Model: Aries-P1.5	Date: 04-Oct-10	No.: RM077001h
-------------------	-----------------	----------------

Subject: Firmware Release Note: Engine		Prepared by: T. Miyamoto	
From: 1st PP Tech Service Sect., PP Tech Service Dept.			
Classification:	<input type="checkbox"/> Troubleshooting <input type="checkbox"/> Mechanical <input type="checkbox"/> Paper path <input type="checkbox"/> Product Safety	<input type="checkbox"/> Part information <input type="checkbox"/> Electrical <input type="checkbox"/> Transmit/receive <input checked="" type="checkbox"/> Other (Firmware)	<input type="checkbox"/> Action required <input type="checkbox"/> Service manual revision <input type="checkbox"/> Retrofit information <input checked="" type="checkbox"/> Tier 2

This RTB has been issued to announce the firmware release information for the **Engine**.

8. Frame Section (B833)

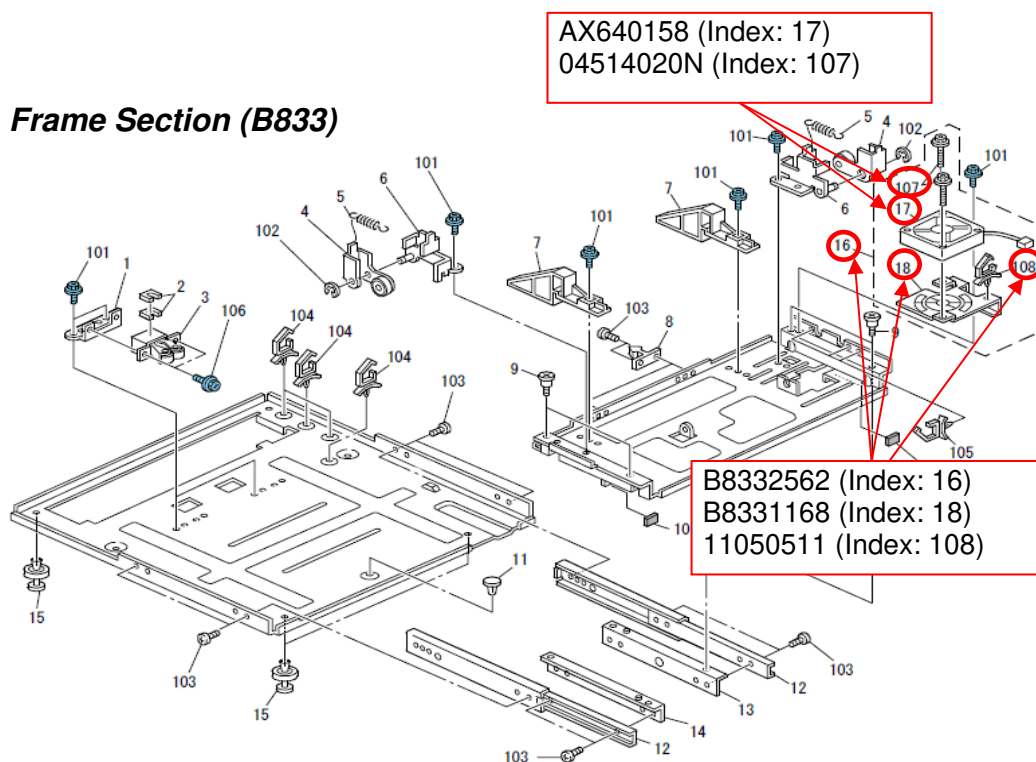
Part number	Description	Q'ty	Int	Page	Index	Note
B8332562	COOLING UNIT:ASS'Y	1		17	16	Add
AX640158	FAN MOTOR MM60/15MM:24V	1		17	17	Add
B8331168	STAY:COOLING UNIT	1		17	18	Add
04514020N	TAPPING SCREW - M4X20	2		17	107	Add
11050511	HARNESS CLAMP – LWS-0306ZC	1	-	17	108	Add

58.Fusing Unit 7 (D095/M077)

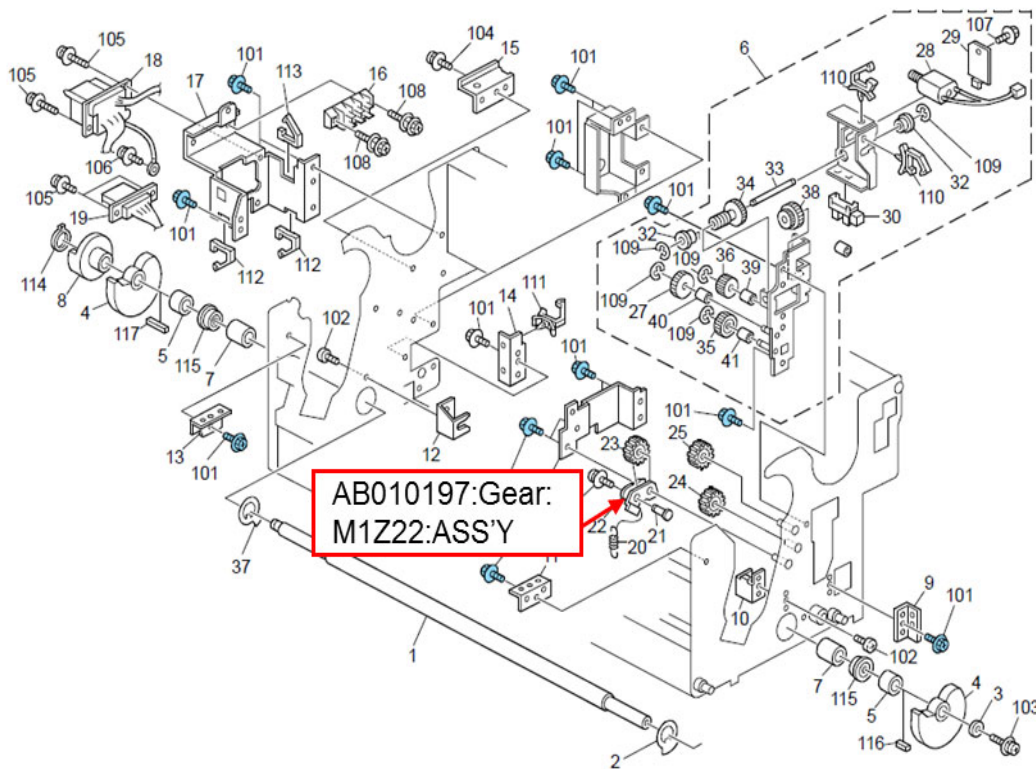
Old p/n	New p/n	Description	Q'ty	Int	Page	Index	Note
-	AB010197	GEAR:M1Z22:ASS'Y	1	-	141	42	Add

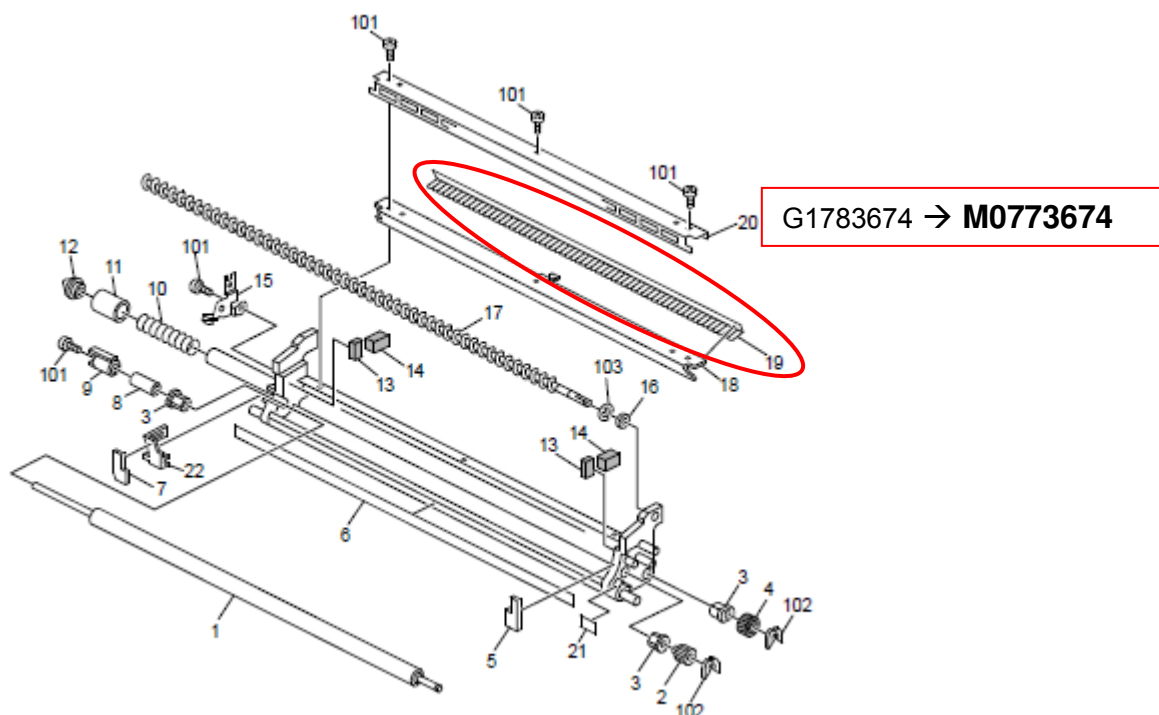
Old Part Number	New Part Number	Description	Q'ty	Int	Page	Index	Note
G1783674	M0773674	VIBRATINGPLATE: TONER COLLECTION COIL	1	X/O	99	19	Change

34.PCDU 1 (D095/M077)

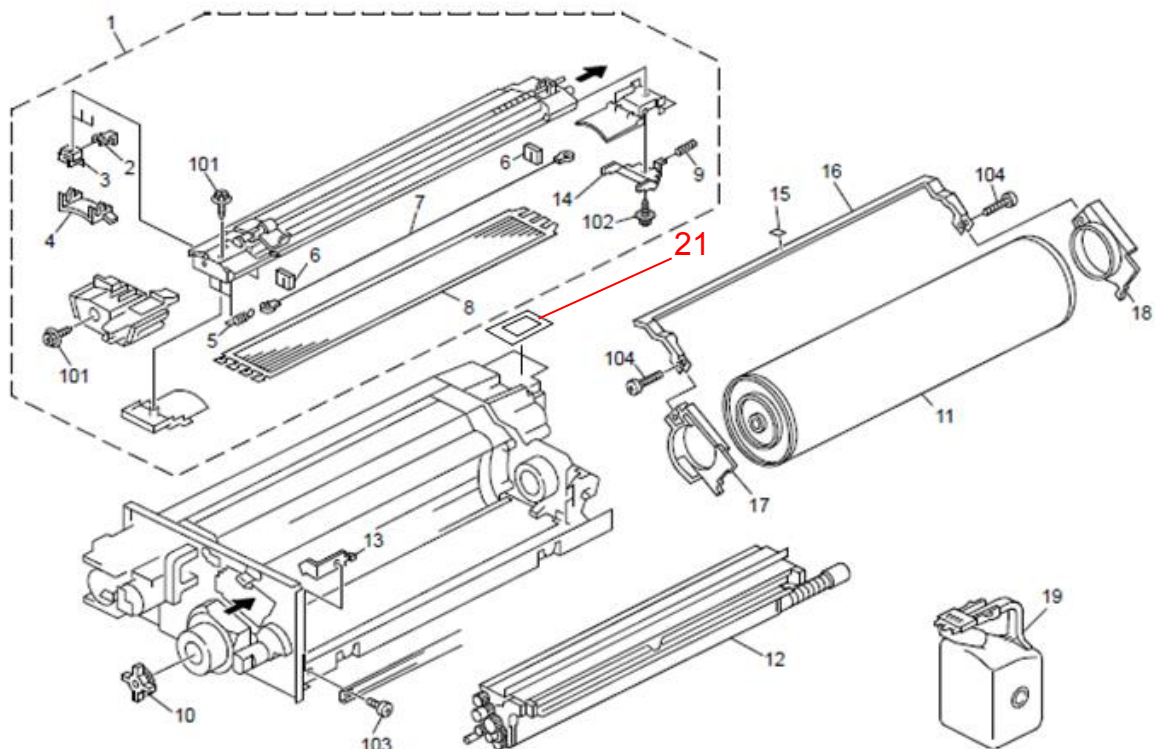
Old part number	New part number	Description	Q'ty	Int	Page	Index	Note
-	G1783475	SPONGE:COUPLING:TONER SUPPLY:DEVELOPMENT UNIT	1	-	93	21	New Index

126.Paper Tray 6 (D095)

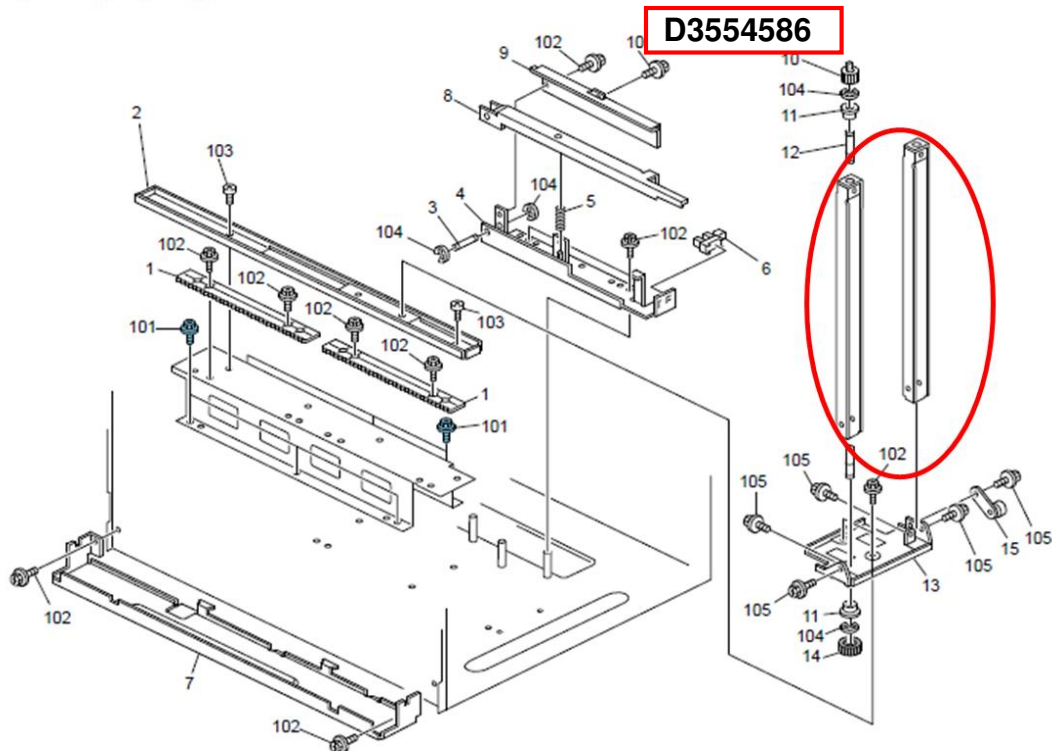
Model	P/N	Description	Q'ty	Int	Page	Index	Note
Aries P1.5/C1.5	D3554586	STAY:END FENCE	1	-	277	16	Add
AG P1/C1			1	-	277	17	Add
LCIT5020			1	-	17	17	Add

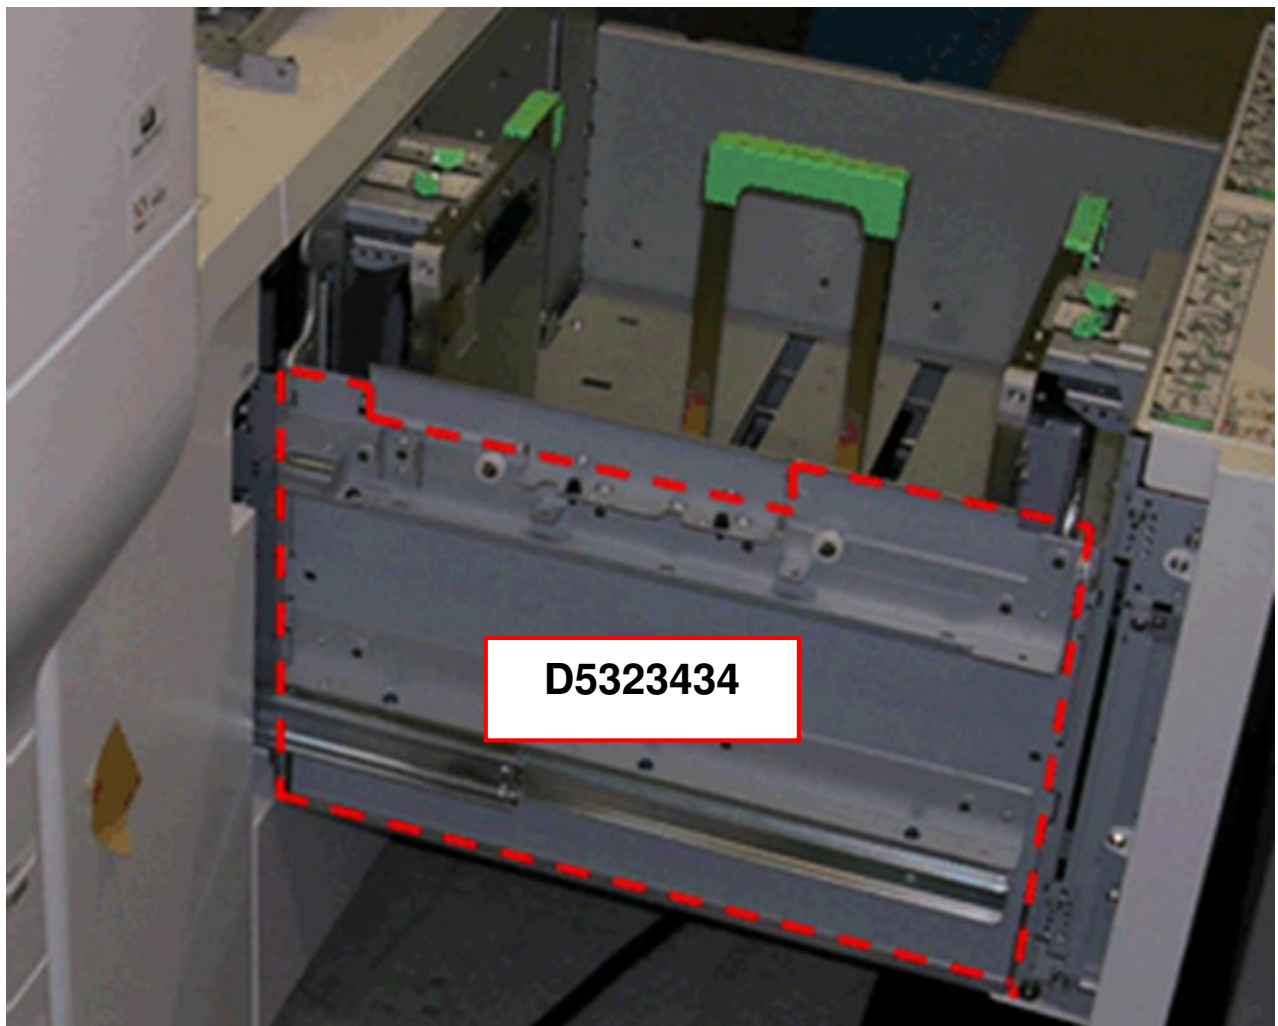
Old P/N	New P/N	Description	Q'ty	Int	Page	Index	Note
-	D5323434	DRUMSTAY:PAPER FEED: WELDING	1	-	267	26	Add
